ADDENDUM NO. 4

Reference: Gibson Science Center Addition
Southern Utah University – Cedar City, Utah
DFCM Project No. 07297730

Subject: **Addendum No. 4**

Sheet No.
AD04-SS09
Sheet Reference
SF101

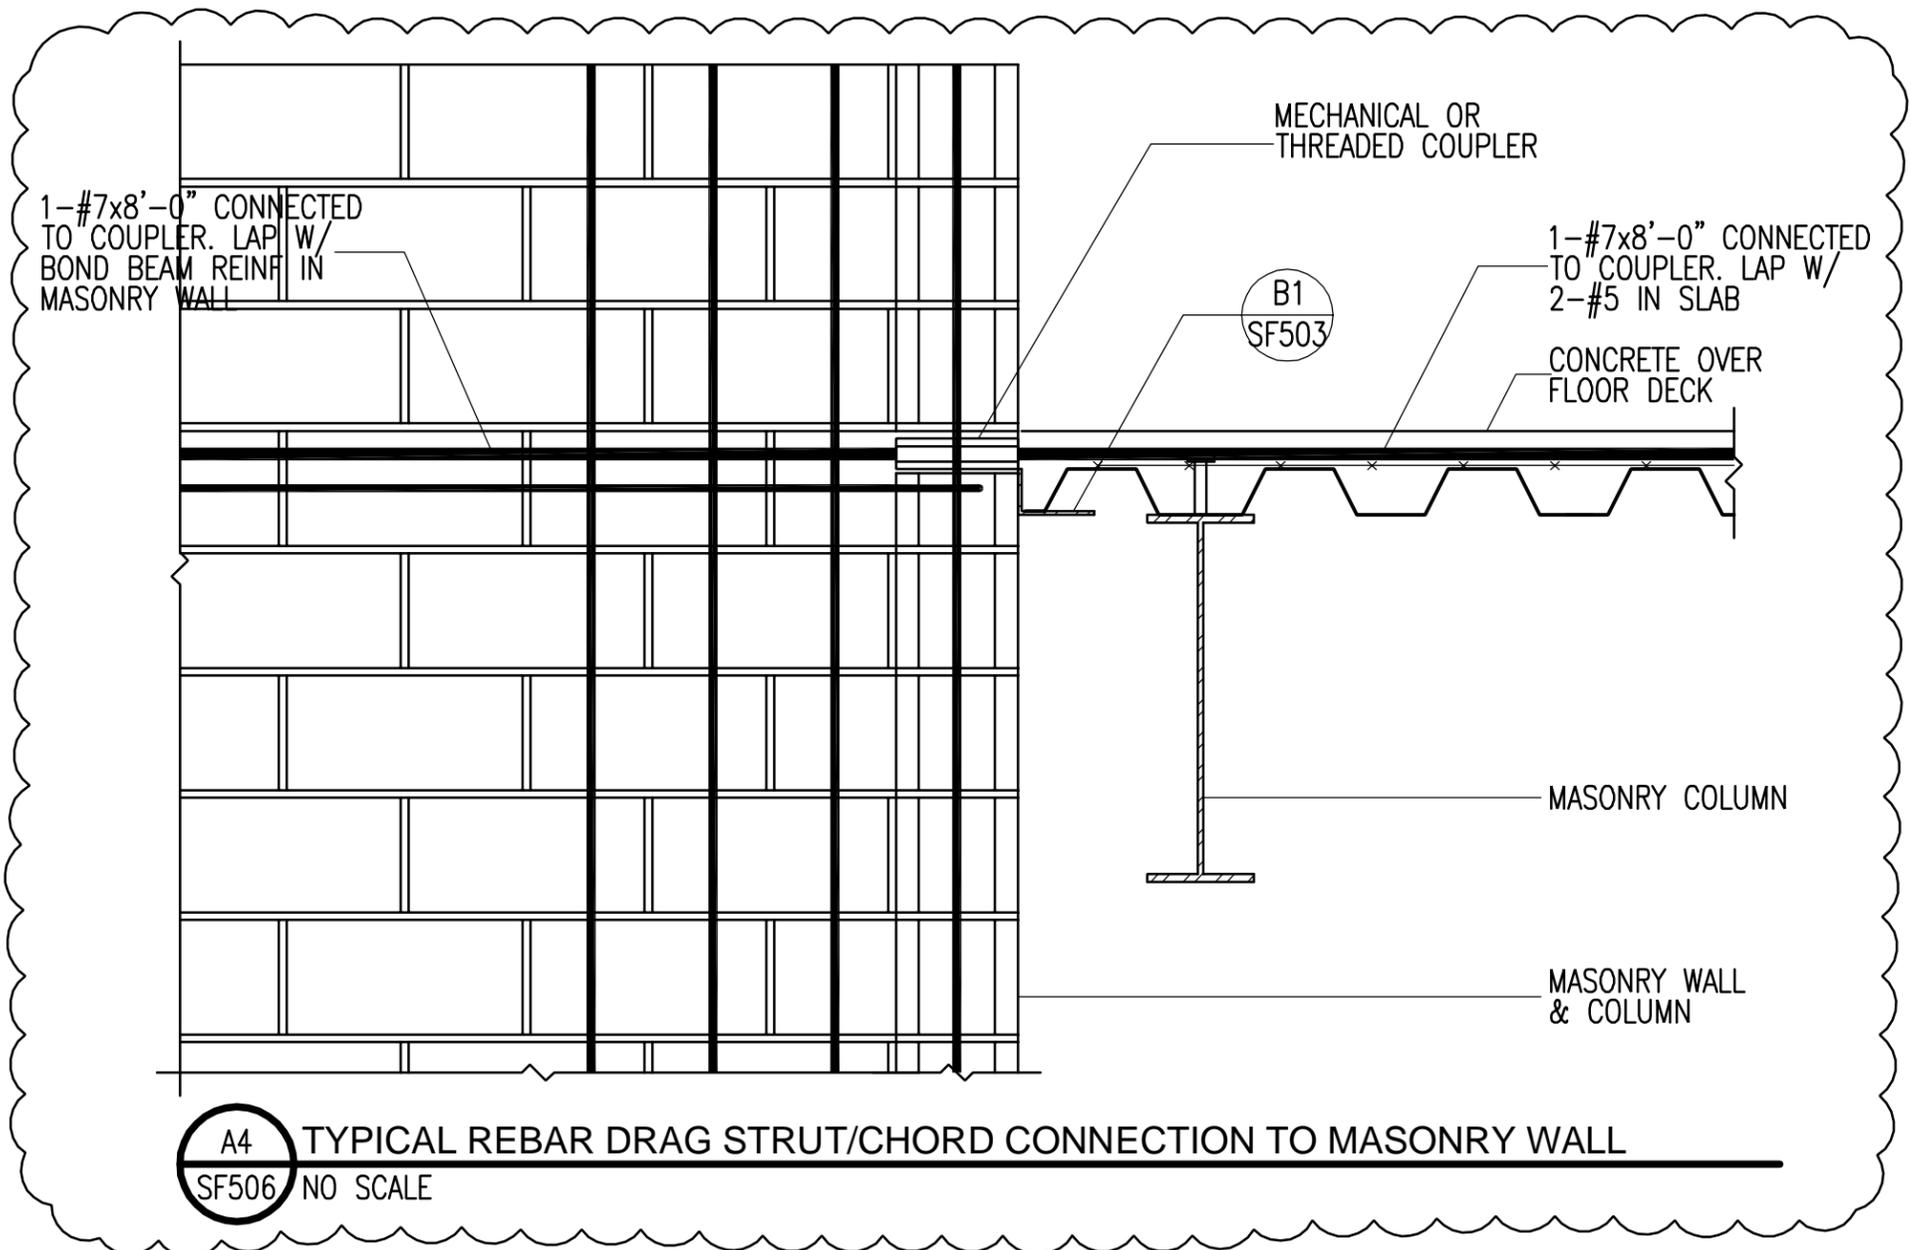
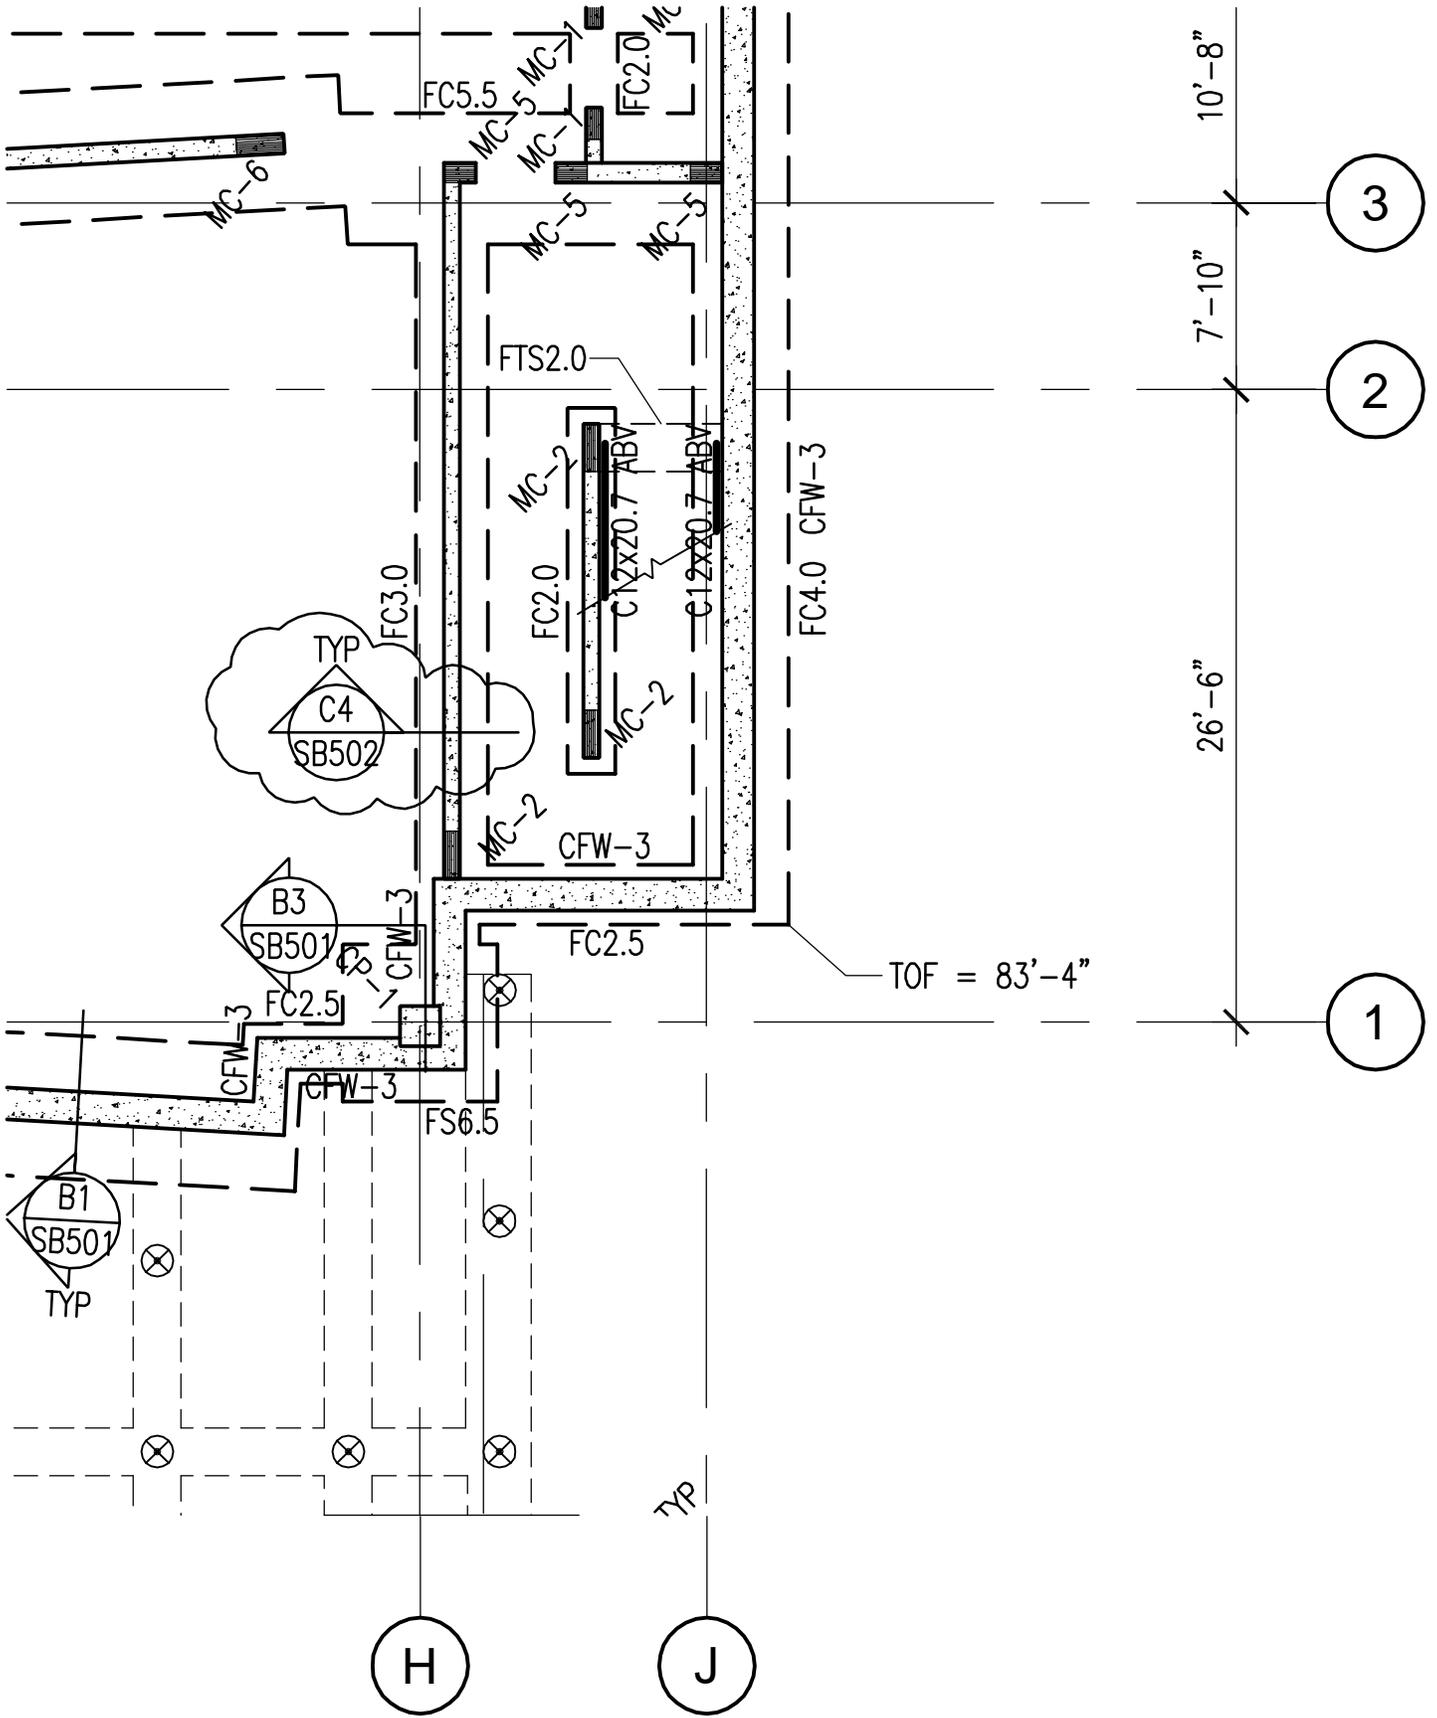
- S1.4 Re: SB601: .CGB-1 revised and CGB-4 added to CONCRETE GRADE BEAM SCHEDULE. Drawing AD04-SS03 attached.
- S1.5 Re: SF101: Add detail cut A4/SF506 Typ./Sim. Drawing AD04-SS09 attached

Sheet No.
AD04-SS11
Sheet Reference
SB101

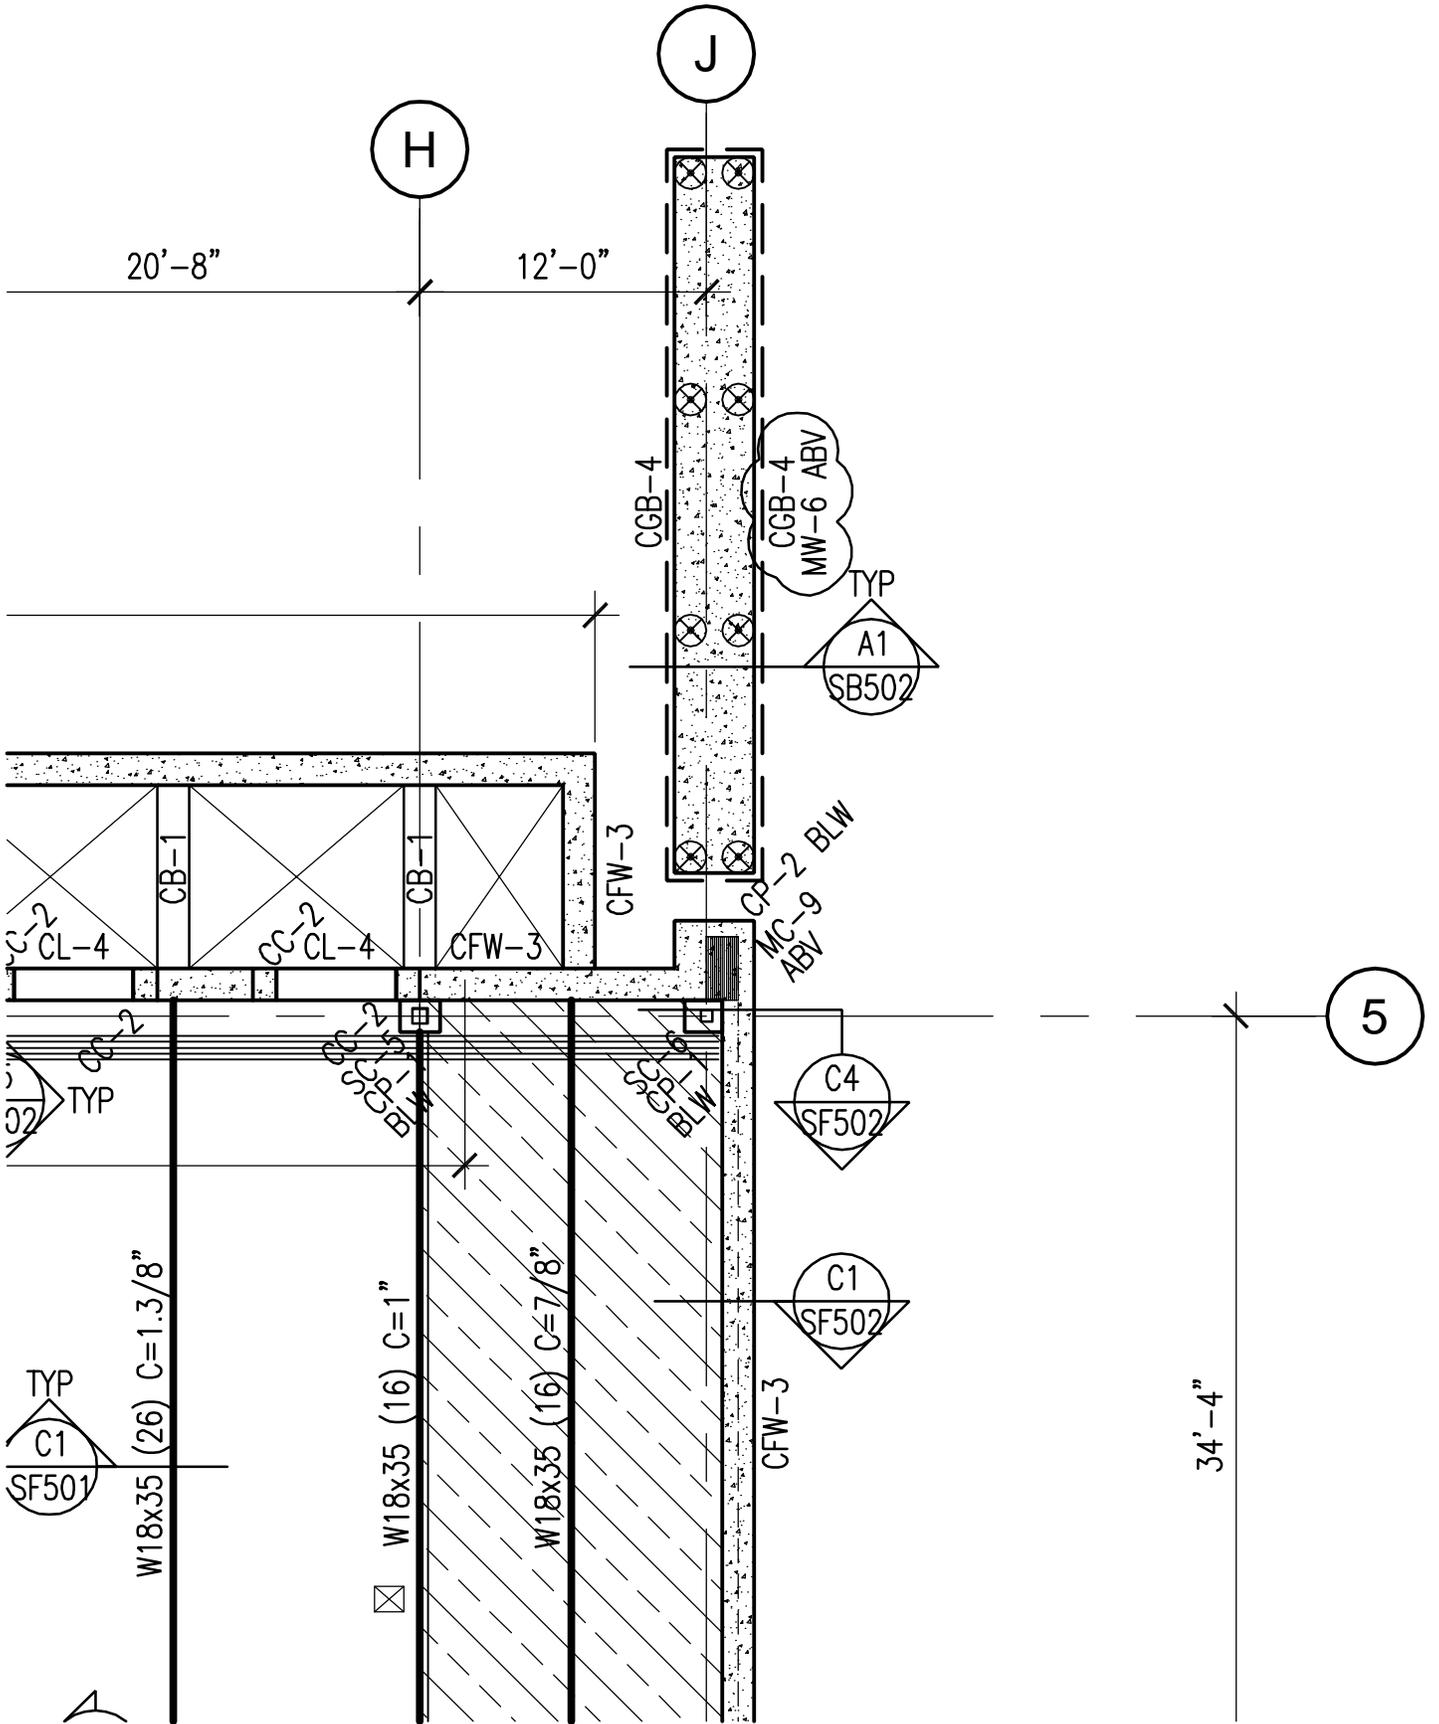
- S1.1** Re: SB101: Revised detail cut near grid H and between grid 1 and grid 2. Drawing AD04-SS11 attached
- S1.2** Re: C5/SB504: Detail altered to show truncated text. Drawing AD04-SS01 attached
- S1.3** Re: SB601: FC4.5 and FC5.5 added to CONCRETE FOOTING SCHEDULE. Drawing AD04-SS02 attached.

Sheet No.
AD04-SS12
 Sheet Reference
 SF101

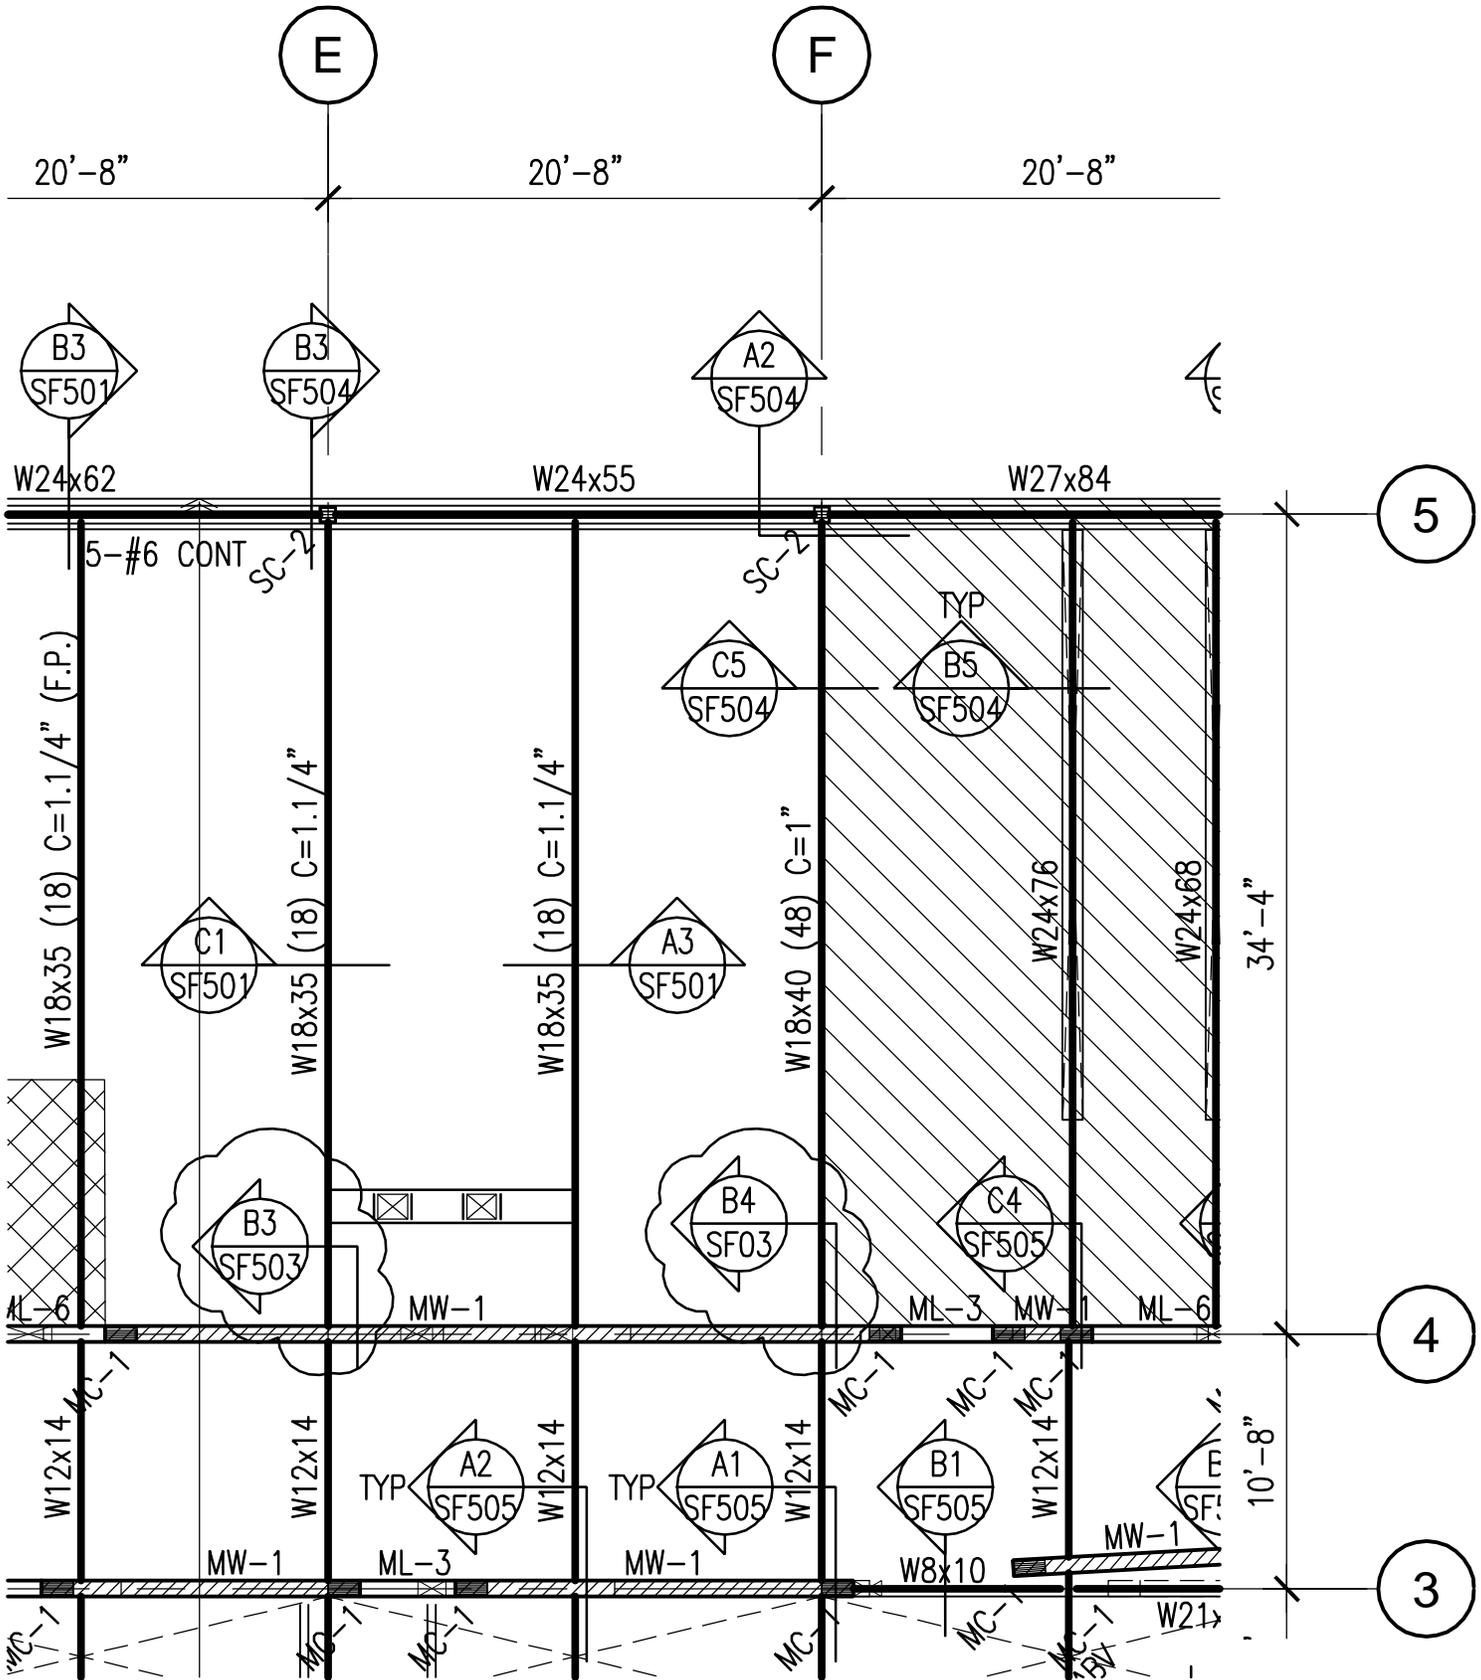
- S1.6 Re: SF101: Revised footing mark to CGB-4 for footing below screenwall located near grid J and above grid 5. Drawings AD04-SS12 attached.
- S1.7 Re: SF102: Add detail cut A4/SF506 Typ. Drawing AD04-SS08 attached
